**FROM:** Debra Singleton, Engineer  
Detroit Water and Sewerage Department

**RE:** Petition #1033  
Request for Conversion To Easement Of Artesian Ave. Between Glendale, And  
Jeffries Freeway (I-96)

CONVERSION TO EASEMENT  
 ARTESIAN AVE. 86 FT. WD.  
 BETWEEN  
 GLENDALE AVE. AND JEFFRIES FWY.

CITY OF DETROIT CITY ENGINEERING DIVISION SURVEY BUREAU	
JOB NO.	01-01
DRWG. NO.	X 1033

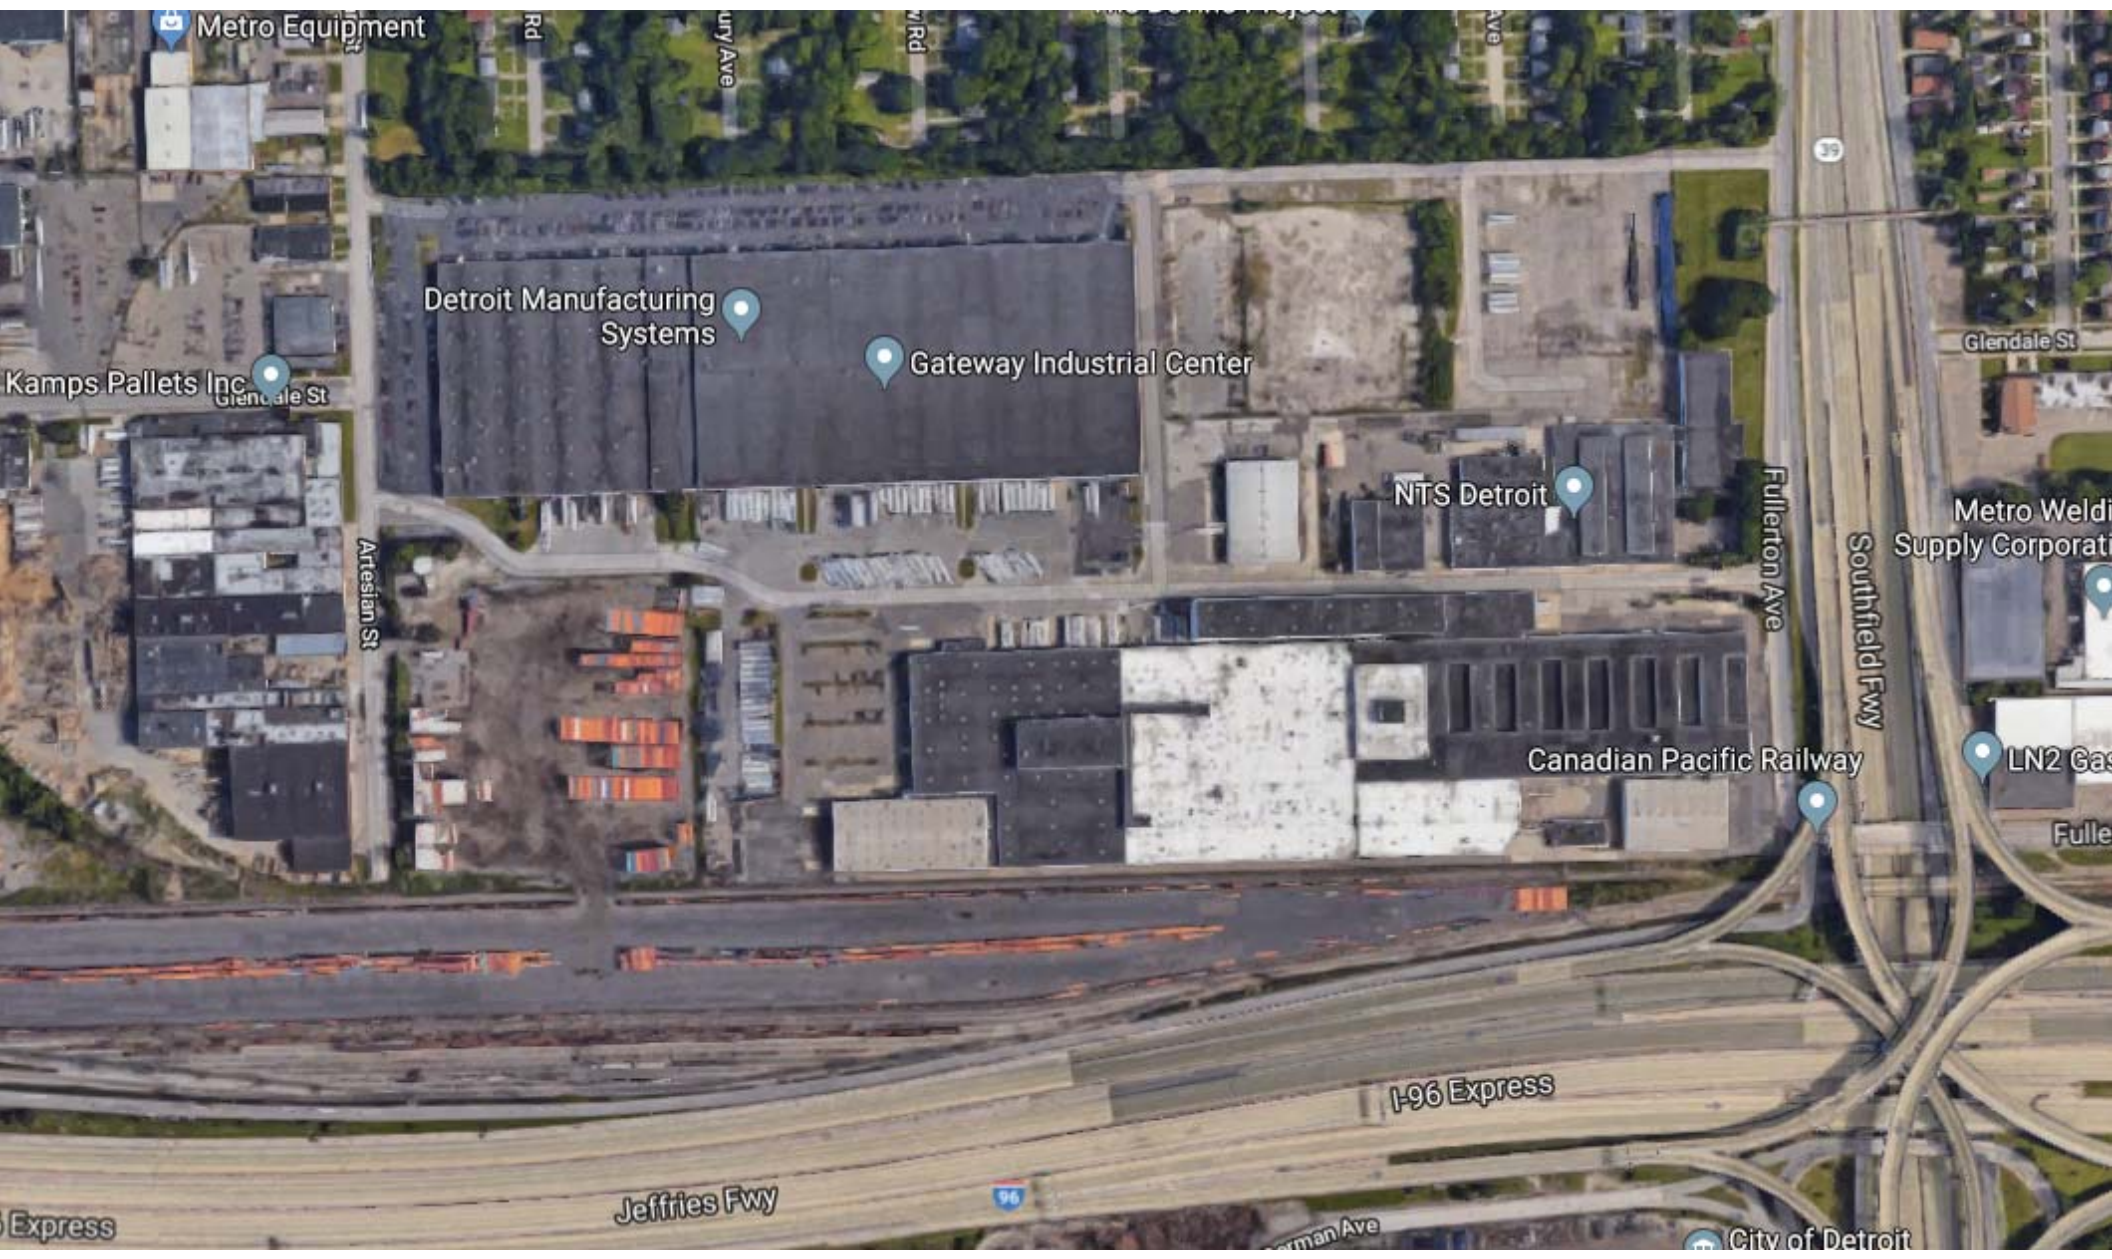
The above petition received by this office has been reviewed. With regard to DWSD's interests, our comments are as follows, our records indicate that there is a sewer and a water main in Artesian Ave., DWSD has no objections to the conversion to easement provided that the attached provisions for conversion to easement are followed.

1. An easement, the full width of the existing right of way, is reserved for the Detroit Water and Sewerage Department for the purpose of installing, maintaining, repairing, removing, or replacing any sewers, water mains, fire hydrants and appurtenances, with the right of ingress and egress at any time to, and over said easement for the purpose above set forth. Any proposed fencing across the easement must have a gate installed to permit access for DWSD forces. The gate shall remain unlocked 24 hours a day, unless a guard is stationed near the gate to allow the Detroit Water and Sewerage Department ingress and egress at any time. The minimum dimensions of the gate or gates shall provide 15 foot vertical and 13 foot horizontal clearances for freedom of D.W.S.D. equipment movement.

2. Said owners of the adjoining property, for themselves, their heirs and assigns, agree that no building or structure of any nature whatsoever, including fences, porches, patios, balconies, etc., shall be built upon or over said easement, or that no grade changes or storage of materials shall be made within said easement without prior written approval and agreement with the Detroit Water and Sewerage Department.
